**Re: Remediation Work Plan Addendum
East Pecos Federal 22 #009H
Incident Numbers NVV2003433576, NRM1935238930, NRM2001038937 and
nAPP2200730406
Eddy County, New Mexico**

Ensolum, LLC (Ensolum), on behalf of WPX Permian Energy, LLC (WPX), has prepared this Remediation Work Plan Addendum (RWPA) to address deficiencies in the January 21, 2021 and April 4, 2022 Remediation Work Plan (RWP) identified by the New Mexico Oil Conservation Division (NMOCD) and to recommit to remedial actions for the East Pecos Federal 22 #009H (hereinafter referred to as the "Site") located in Unit M, Section 22, Township 26 South, Range 29 East, in Eddy County, New Mexico (**Figure 1 in Appendix A**).

SOIL SAMPLE LOCATIONS

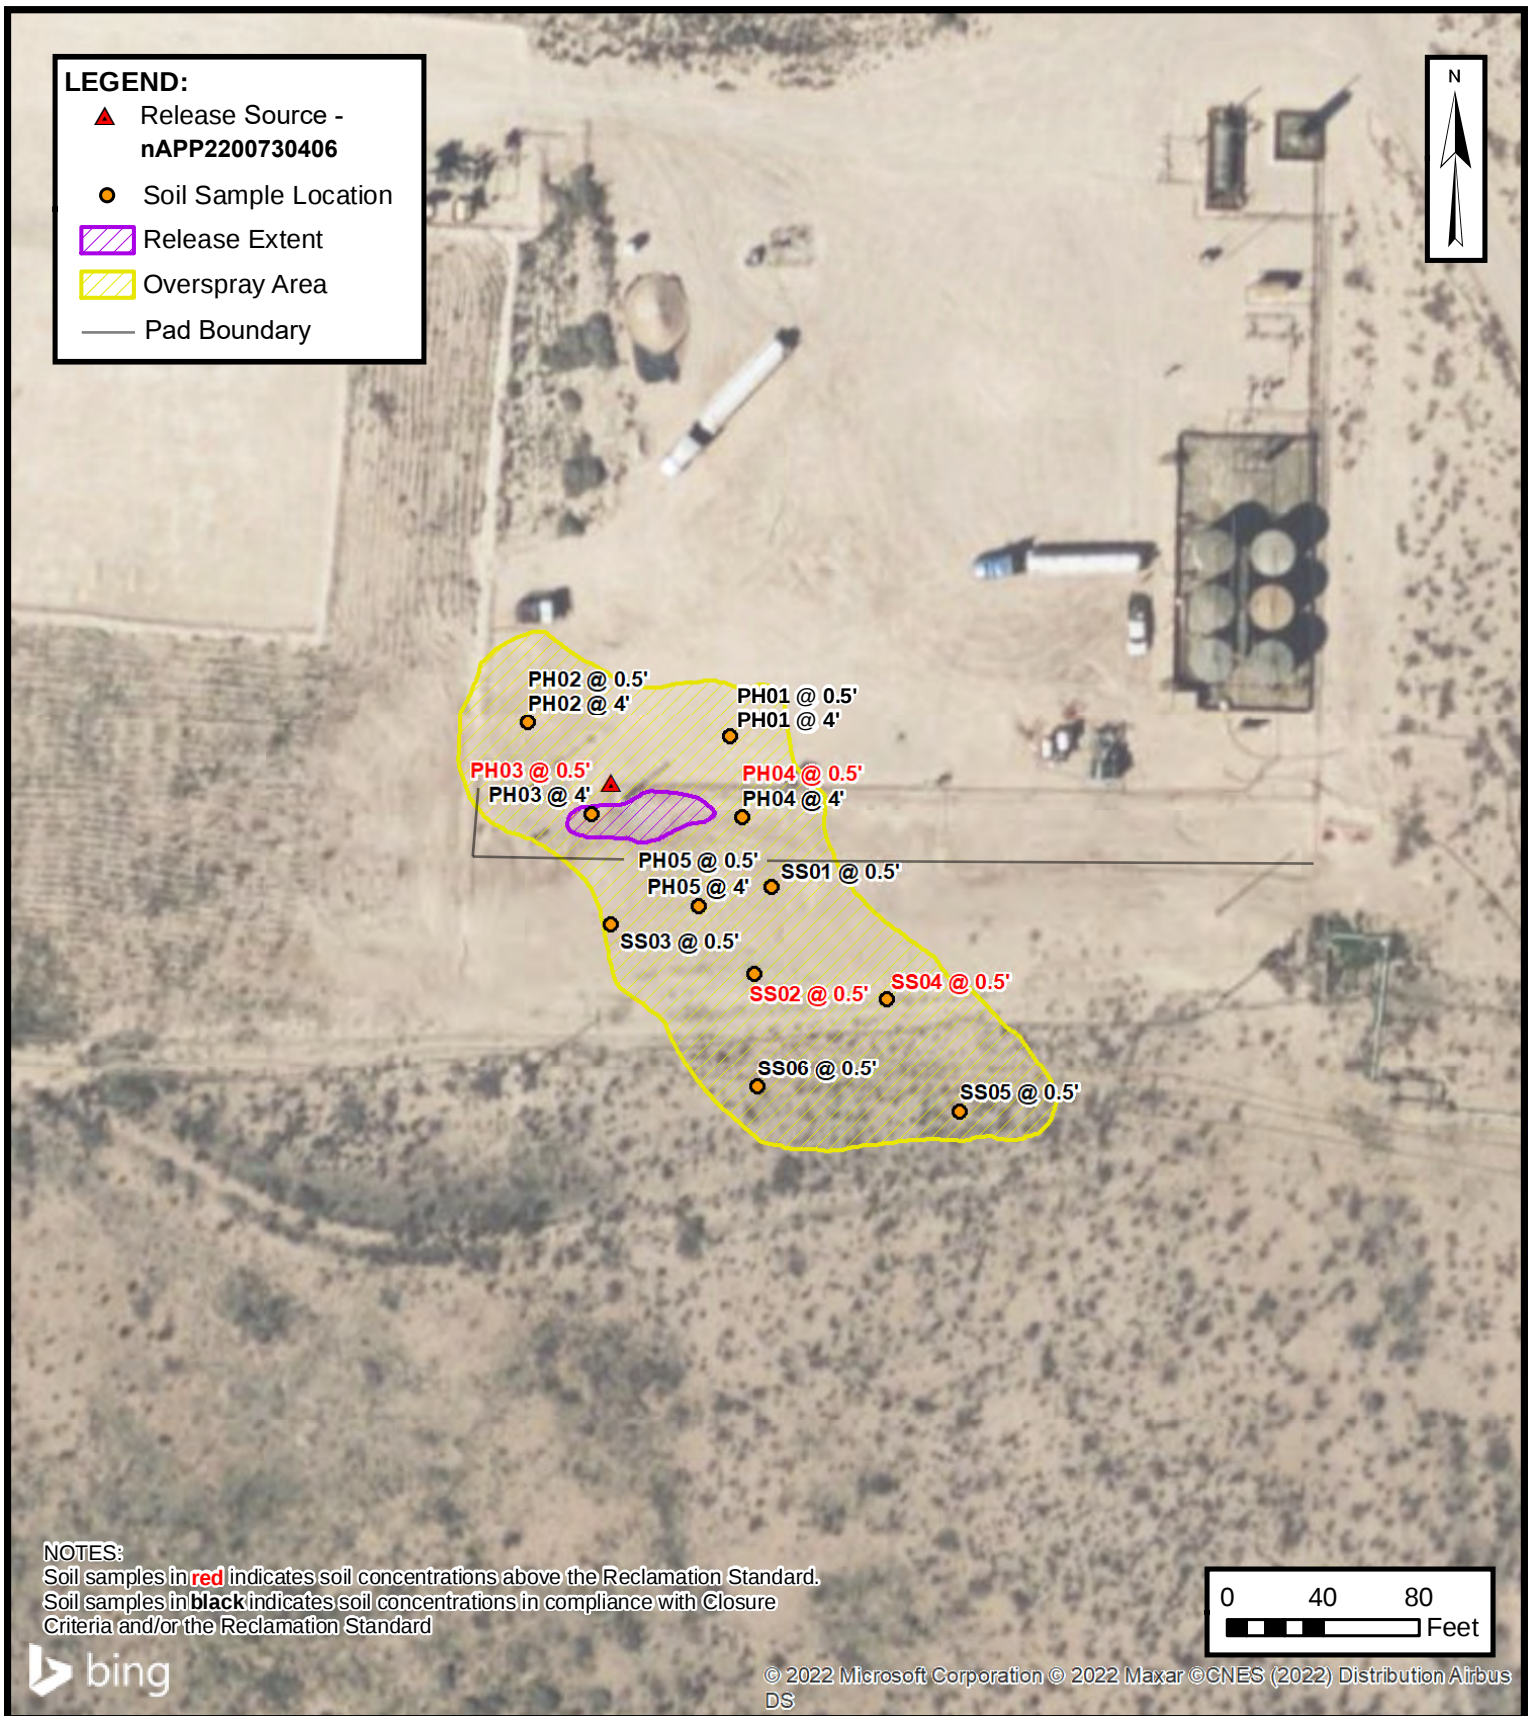
As a result of the denials, a soil boring was installed north of the releases and on location (32.021479, -103.975048) to assess depth to water beneath the Site (**Figure 2 in Appendix A**). WPX contracted Atkins Engineering Associates (Atkins) out of Roswell, New Mexico, to advance a soil boring TW-1 (New Mexico Office of State Engineer (NMOSE) File # C-4630) via solid stem auger to a total depth of 55 feet bgs. Atkins completed the soil boring TW-1 on June 15, 2022. During drilling activities, the lithology and observed soil conditions for evidence of a water-bearing zone were documented by Atkins. Soil boring TW-1 was drilled to 55 feet bgs and was allowed to stabilize for at least 72 hours. The NMOSE Well Record & Log for soil boring TW-1 included in **Appendix C**.

- Based on laboratory analytical results associated with delineation soil samples PH03 and PH04 and surface soil samples SS02 and SS04, concentrations of contaminants of concern (COCs) greater than the NMOCD Closure Criteria will be excavated and sampled in accordance with the Closure Criteria and/or Reclamation Standard (**See Figure 2 in Appendix A**);
